**COMMISSION OF ARCHITECTURAL REVIEW  
STAFF REPORT  
May 22, 2018, Meeting**

11. **COA-034682-2018** (K. Johnson)

**413 Chimborazo Boulevard  
Union Hill Old and Historic District**

**Project Description:** **Construct a new single family home.**

1925 Sanborn Map

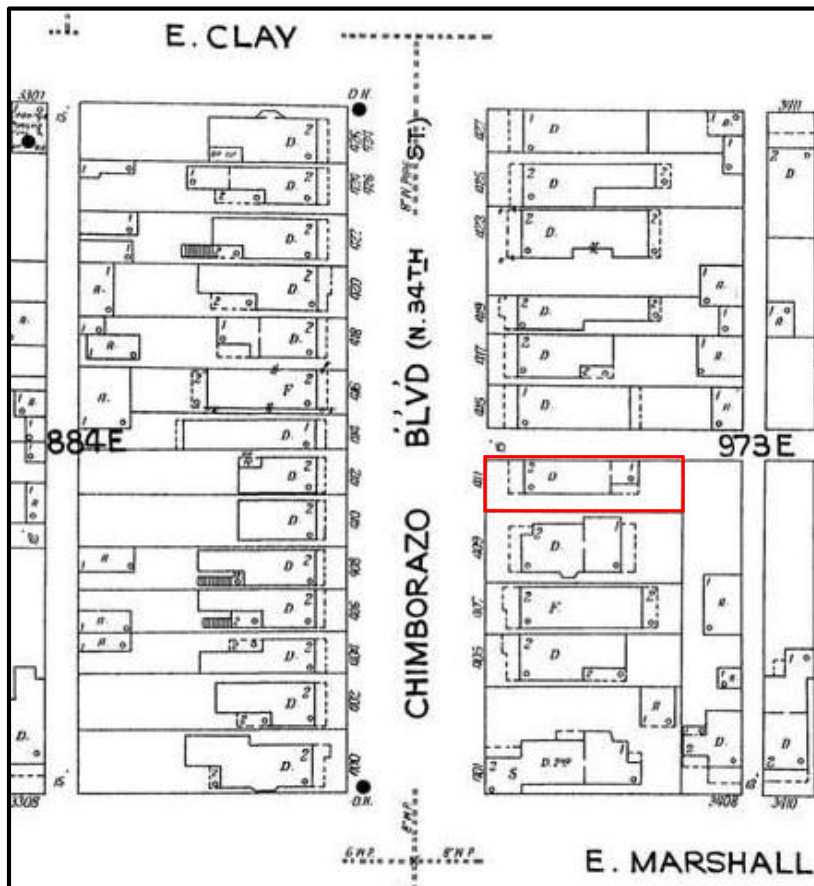
Per the 1925 Sanborn Map, the historic structures on the block have similar front yard setbacks. The applicant has responded to staff's recommendation to not be sitethe structure in front of the structure at 411 Chimborazo Boulevard as to not overwhelm the historic structure. The proposed setbacks are consistent with the historic setback pattern of the block.
